Plan Commission

Agenda

Monday, August 26, 2019

7. Staff recommendation and possible action regarding a Site Plan request for a warehouse addition at 1200 and 1212 Enterprise Drive (Parcels ED-2070 and ED-F0005-2). Submitted by Robert Mach, PE, Mach IV Engineering & Surveying LLC, authorized representative for Amerilux Holdings LLC & Novaks Cheese Enterprises, property owners.

UTILITY PLAN

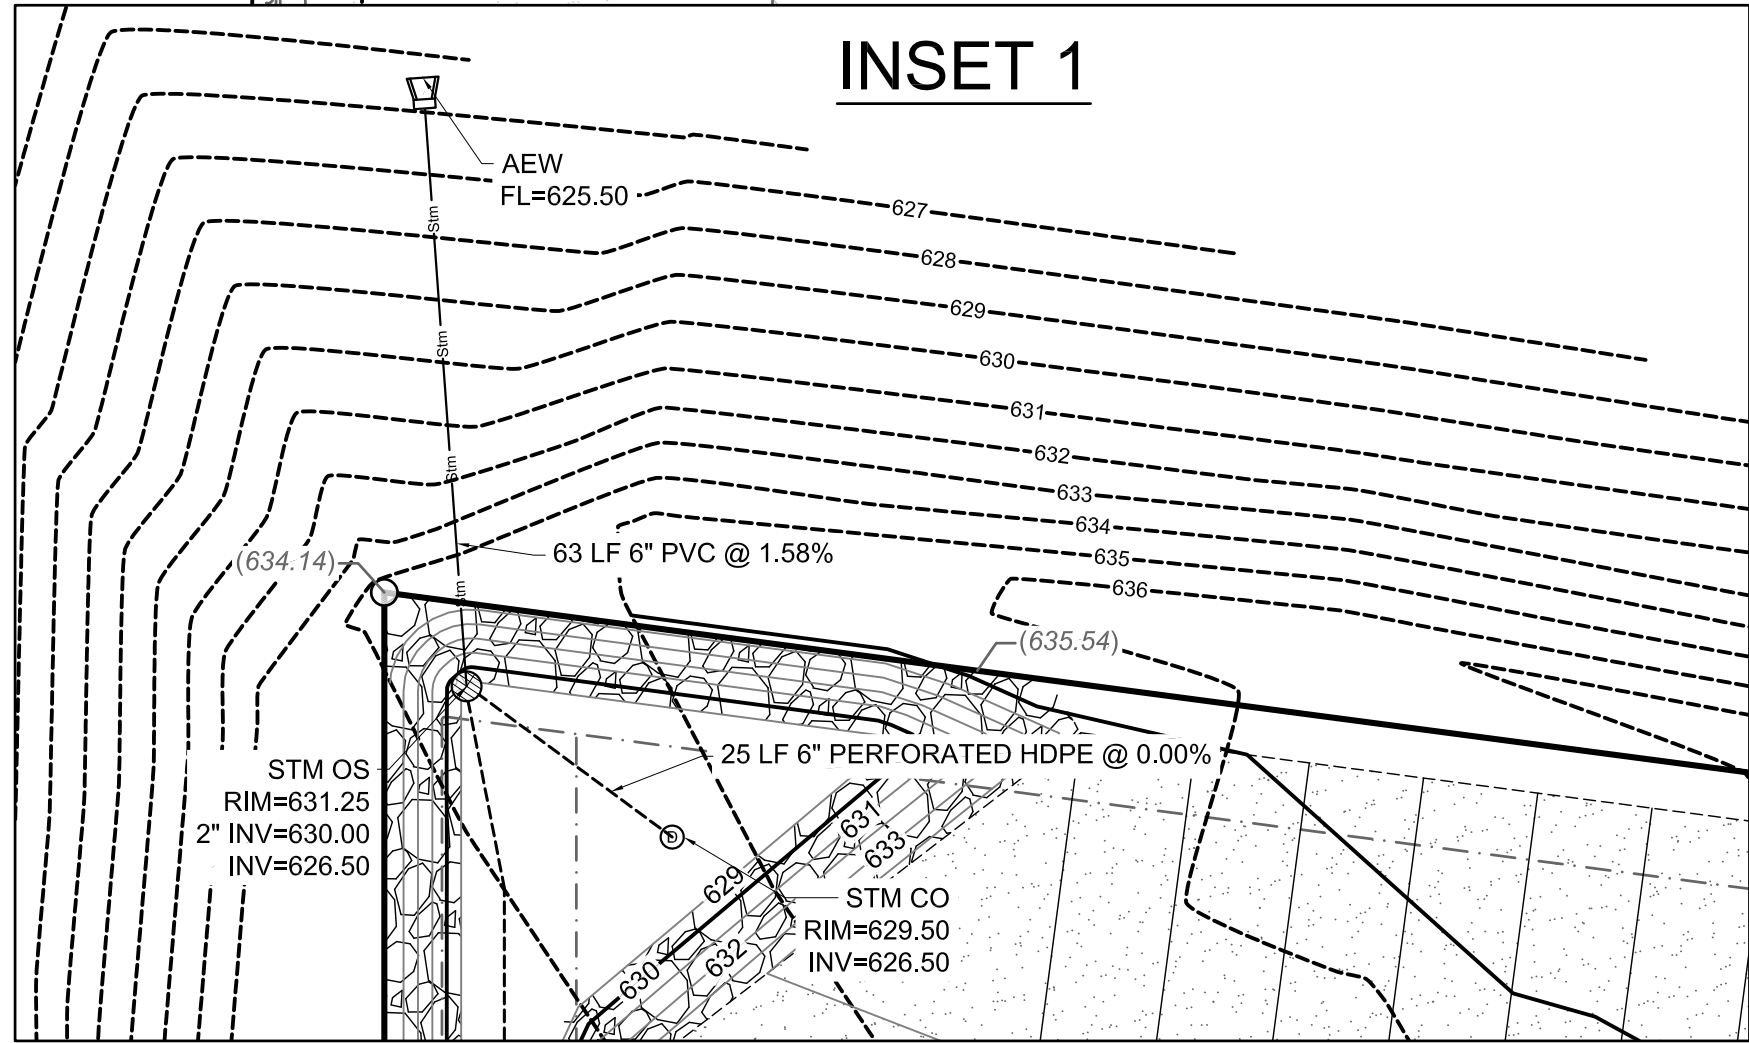
6. Sheet C2.1 - Sheet Key Note #8 should be labeled as 4" striping.
7. Sheet C3.0 - Turn off the existing contour layer from this sheet. It is too confusing to read where the existing landscaping was once located. The contours are not smooth and are creating issues.

8. Sheet C3.0 - Clarify how the design will plan to manage the 1.5-foot cut from the exiting building at the eastern property line to the new parking lot. The FF=637.68 and that proposed corner is touching the 635 contour.

9. Sheet C3.0 - Show the drainage and utility easements on this sheet.
10. Sheet C3.0 - Work leaving the site for the apron end wall in CTH PP right-of-way will need to be permitted with Brown County and potentially WisDOT. The City cannot permit this to be constructed at this time.

PLAN VIEW OF DRIVEWAY APRON

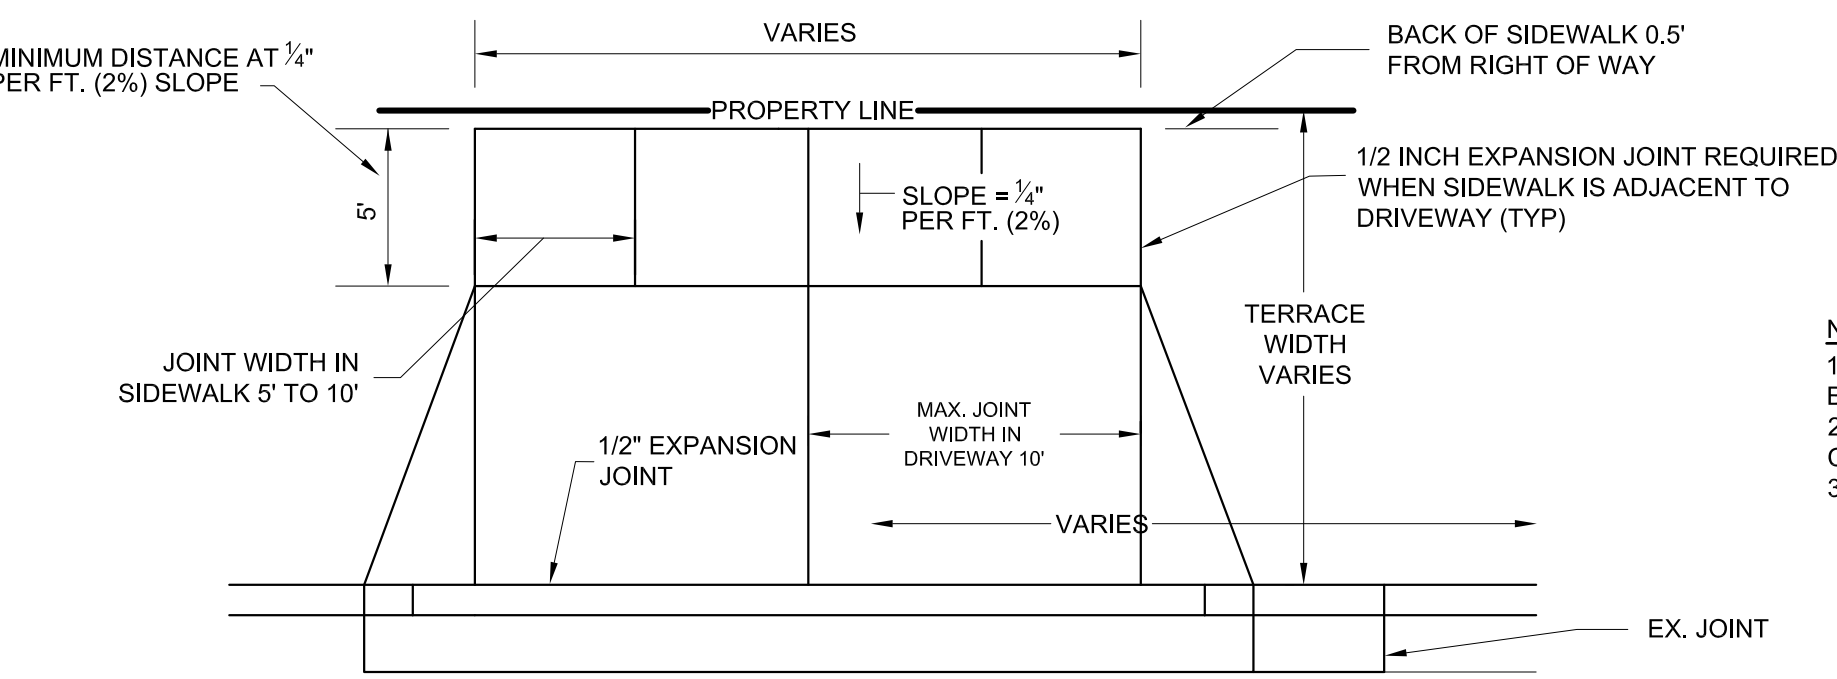
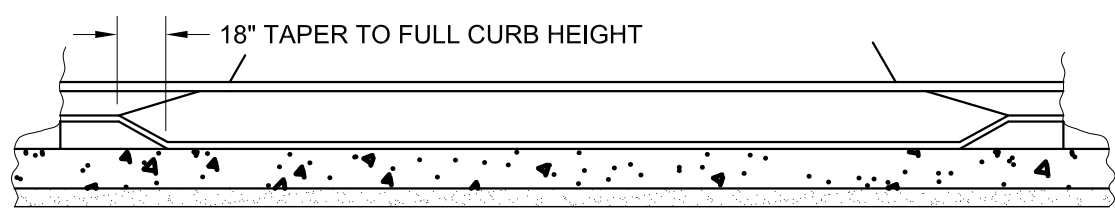
4. Sheet C2.1 - Driveway approach needs to have a sidewalk section shown. Sidewalk section should be approximately 6" off the right-of-way line. This is pursuant to detail F on sheet C6.0.

13. Sheet C6.0 - Detail F should include notes that the work needs to be completed by a licensed concrete worker with the City of De Pere. The permit can be obtained by calling 339-4061. Also, the curb head shall be removed by PROFILE saw cutting only. Saw cutting the flowline and removing the curb head straight down will not be permitted.
